#### Block B NMA Planning Notes

Liddell Road  
West Hampstead

South Elevation  
Building B  
General Arrangement

For Planning

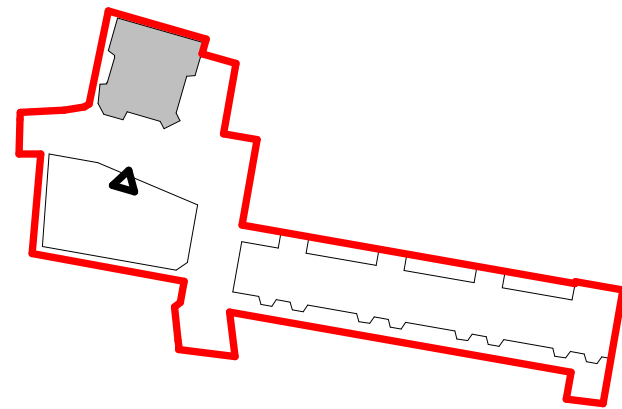
Removal of Juliette balcony where fixed panels window required due to acoustic and ventilation strategy omit. Adjustments to window types to allow for a greater diversity of operable panels.

Minor movements of all brick grids on façade in order to improve build ability and overall aesthetic of the building. Addition of lift and stair overrun to elevation.

Addition of air source heat pump equipment and enclosures to roof space.

Addition of rain water pipes to the external façade. Ground floor layout adjustments required to accommodate 2 substations required for the scheme have affected the overall elevation pattern for the ground floor.

Additional windows added to the ground floor to supply light to Amenity space.
